**DESIGN REVIEW TECHNICAL ADVISORY COMMITTEE MEETING**

**February 23, 2015**

**DESIGN REVIEW TECHNICAL ADVISORY COMMITTEE STAFF REPORT**

Date: February 23, 2015  
 Applicant: NewBo Sushi  
 Owner: Kory Nanke  
 Location: 1201 3<sup>rd</sup> Street SE  
 Request: Sign Permit Review  
 Date Application Received: February 12, 2015

FILE NAME 32264-01-2 DATE 10/09/14  
 JOB NAME NEWBO SUSHI  
 LOCATION USA  
 DRAWN BY DJ'S SCALE 1/2" = 1'  
 SALESMAN AARON VOSMEK

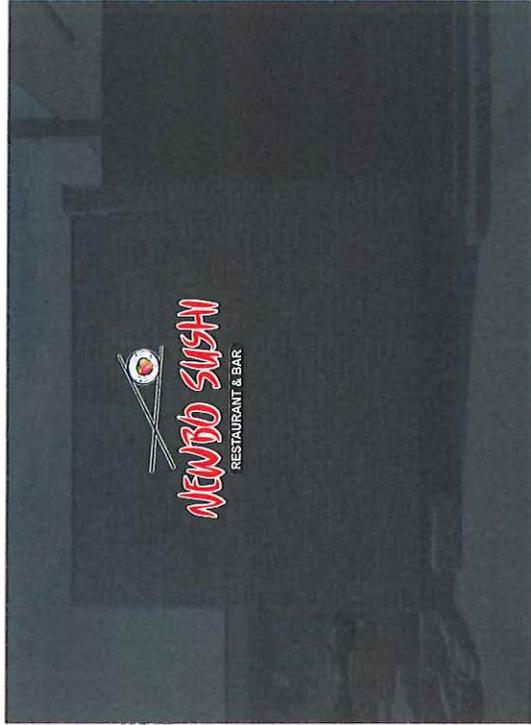
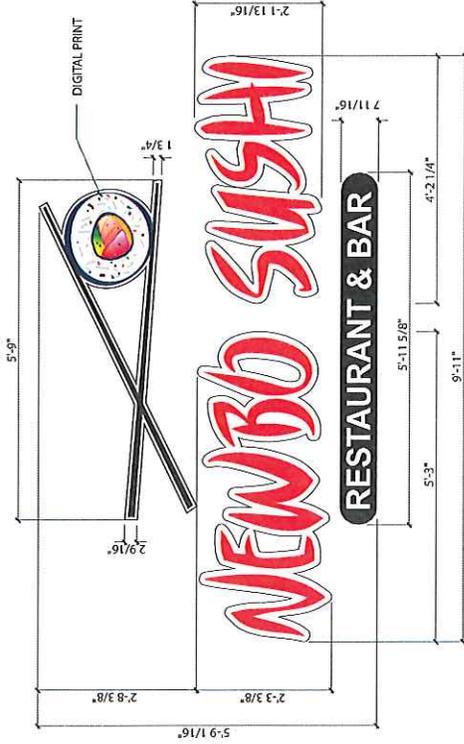
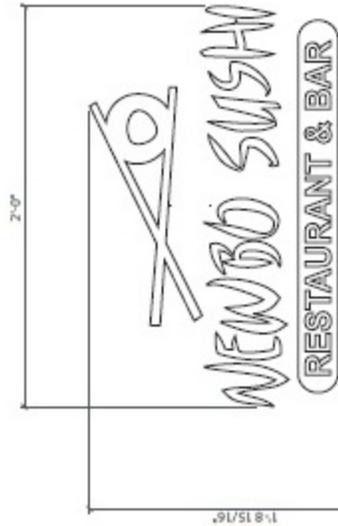
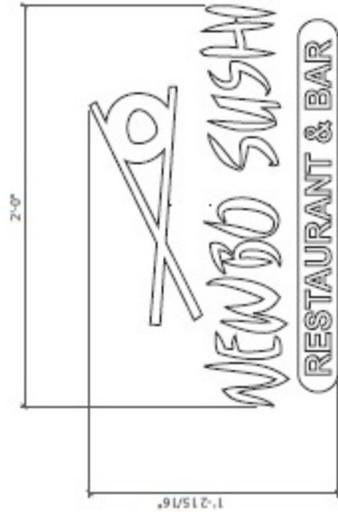
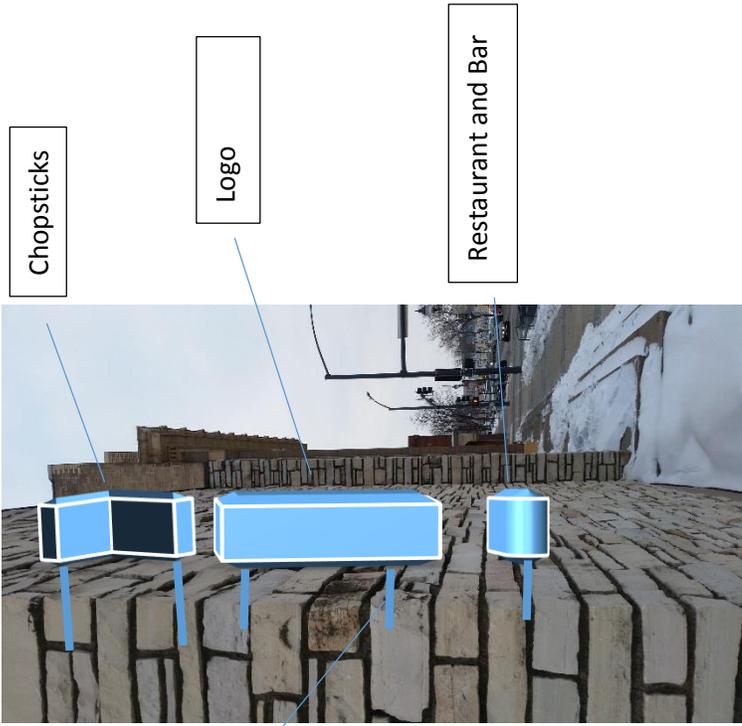
1. Try to attach the sign to the building through the joints

SHEET TITLE  
ELEVATIONS

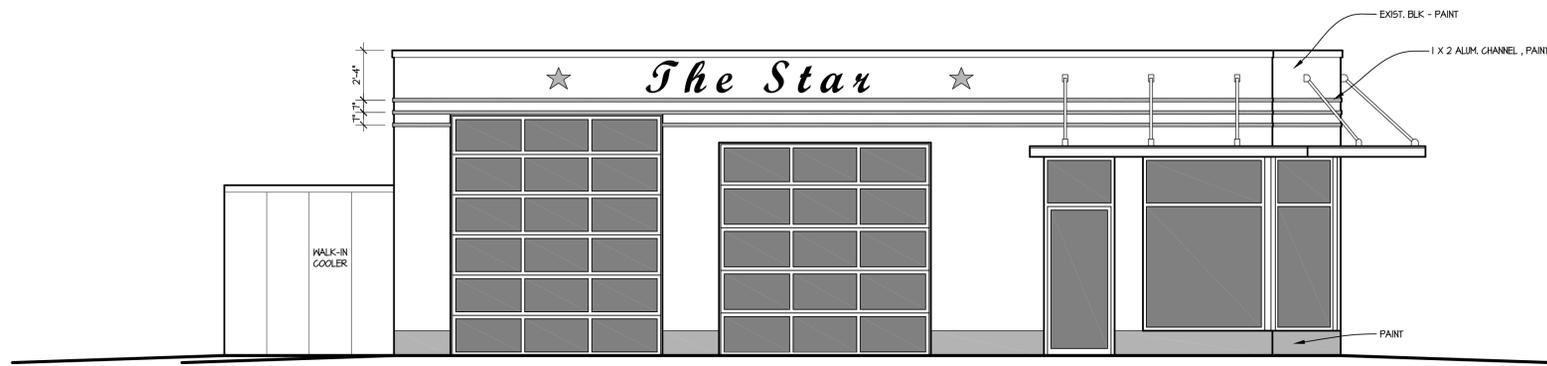
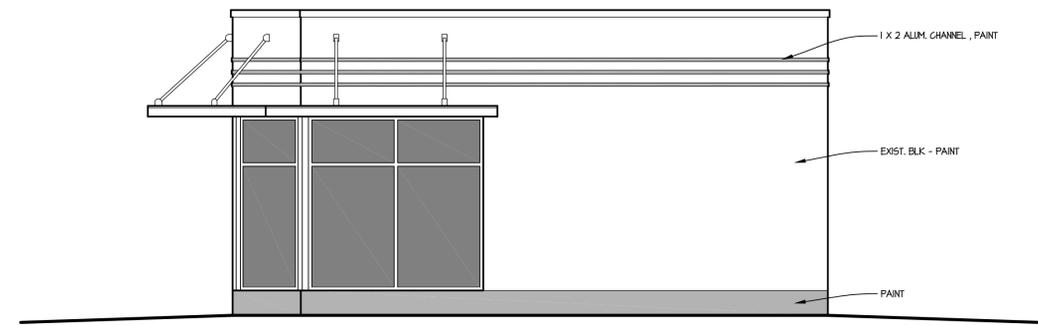
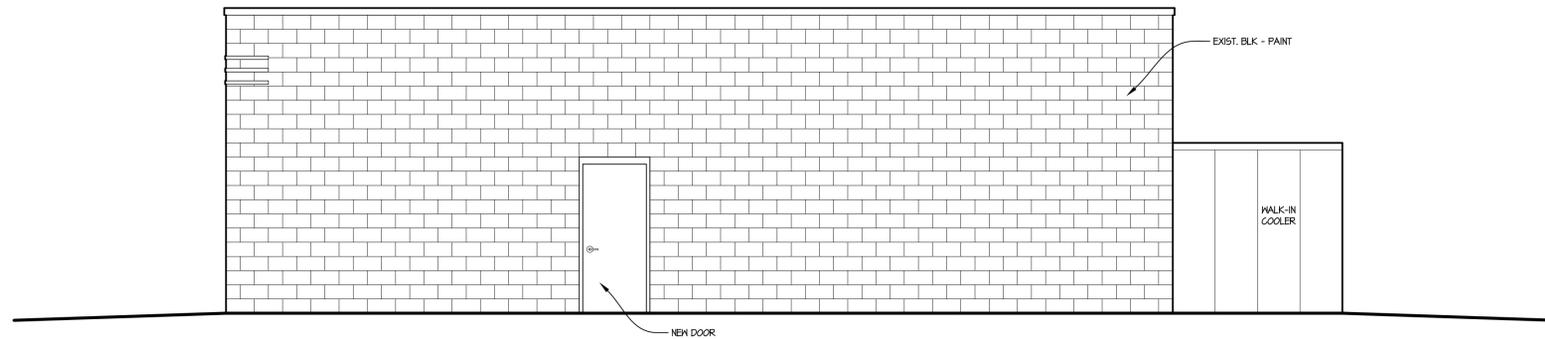
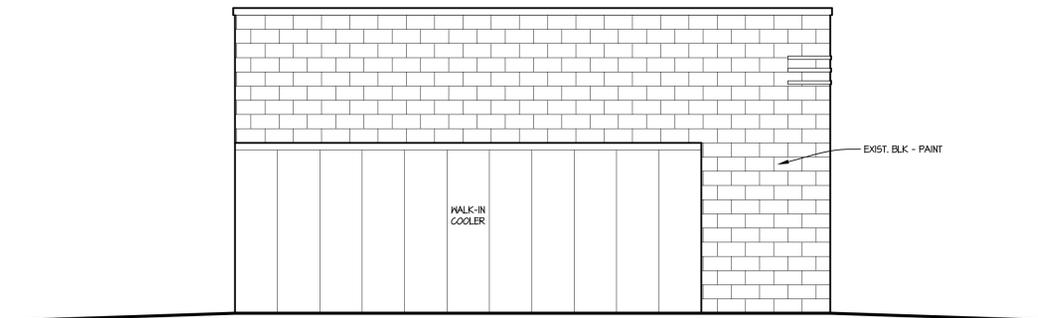
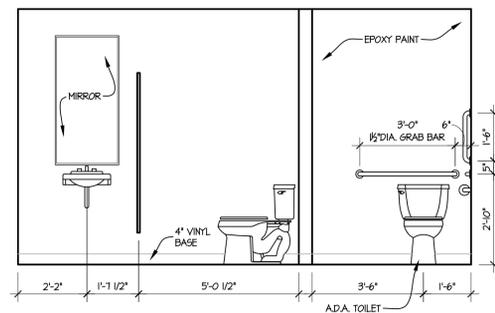
There are no proposed additions to the building. The garage doors could change from what is shown in the renderings. The height of the fencing around the patio depends on the level of staff service. The project will come back before DRTAC for a review of the fence/patio area.

1. Windows should be similar to the ones used for Red Ball Printing
2. Paint the screening for the cooler so that it matches the building
3. Consider using the existing awning and sign post
